**REAR WHEEL RIM TIRE AND TUBE FLAP - SPORTSTER**

**TIRE FLAP INSTALLATION****HARLEY-DAVIDSON MOTOR CO.**

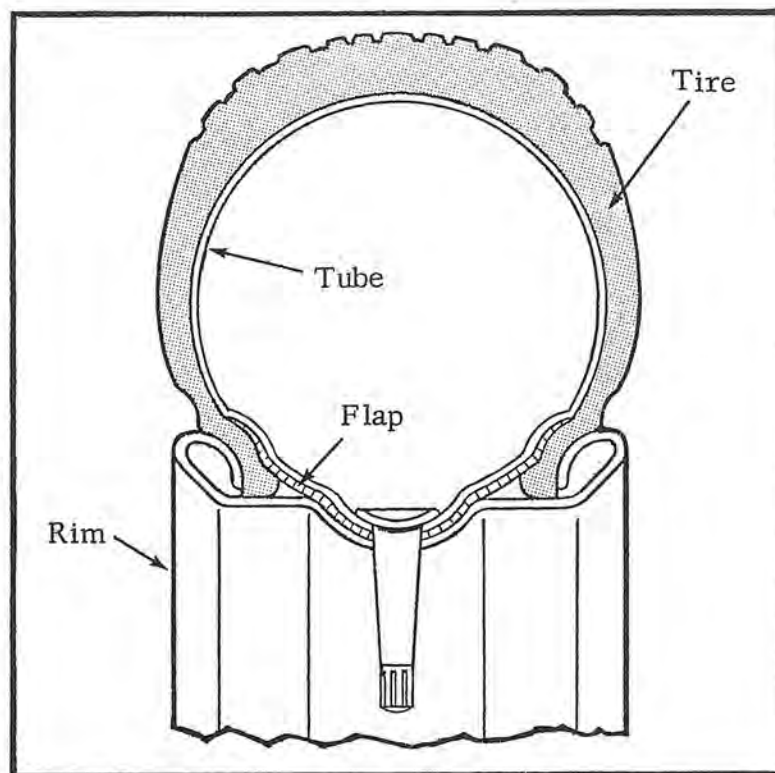
Starting September 20, 1966 a rubber protection band is being installed between the inner tube and tire bead on all 1967 Sportster rear wheel steel rims only. This is a wide band which is used instead of the narrow band formerly used around the spoke nipple surface on the rim. This change was made to provide greater protection against possible tube wear caused by the tire bead edge rubbing on the tube at this point under very severe operating conditions, such as off the highway service, or maximum acceleration and braking conditions.

This tube flap is available from the factory under Part No. 43148-67 with installation instructions included. Use of this flap is recommended as an extra safety precaution on all earlier Sportster motorcycle rear wheels where tube wear may be a factor.
